## **Incomplete Application Response**

24-121106-PLN | 3021-3027 D Street NE

This letter shall serve as the applicant's response to an incomplete application notice received on November 8, 2024. This response is organized by item in the same order as the incomplete letter.

Item 11: Setbacks (to trash enclosure)

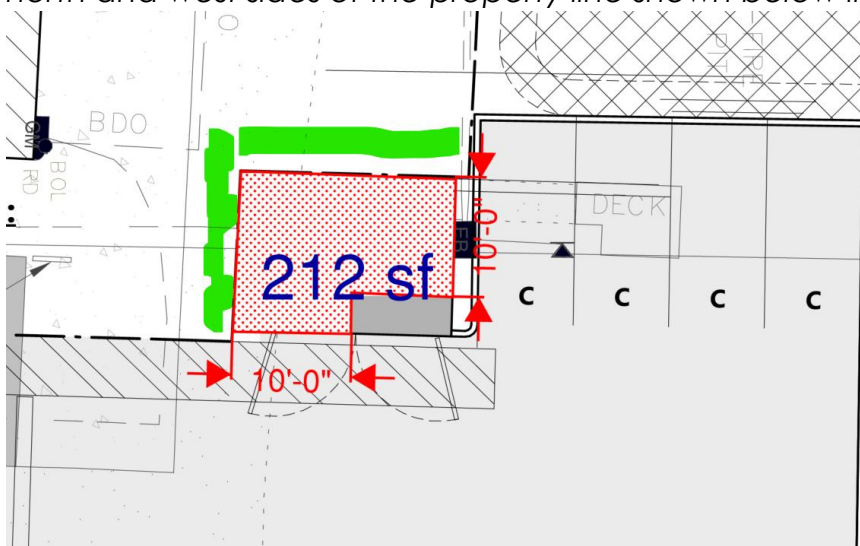
**Applicant's Response:** The applicant requests an additional adjustment to the setback requirement for the trash enclosure.

**Finding:** The applicant understands the purpose of the setback to the accessory structure (trash enclosure) on the multifamily portion of the development site is to afford light, air, and green space between structures. Due to the narrow configuration of the site, the requirement to tuck vehicle parking behind the buildings, the low portion of the site where the GSI must be located, meeting the setback requirement to the accessory structure is not feasible on this site. To equally meet the intent of the requirement being adjusted, the applicant proposes to place additional plant units on proposed parcel 1 side of the sight obscuring fence. The setback requirement is 10 feet to the accessory structure which is a displacement of approximately 212 square feet of landscaped setback. The applicant proposes to move the plant units, totaling 11 PUs ( $212 / 20 = 10.6$  plant units rounded to 11) to the north and west sides of the property line shown below in green.

*With the mitigation proposed, the requested adjustment meets the approval criteria.*
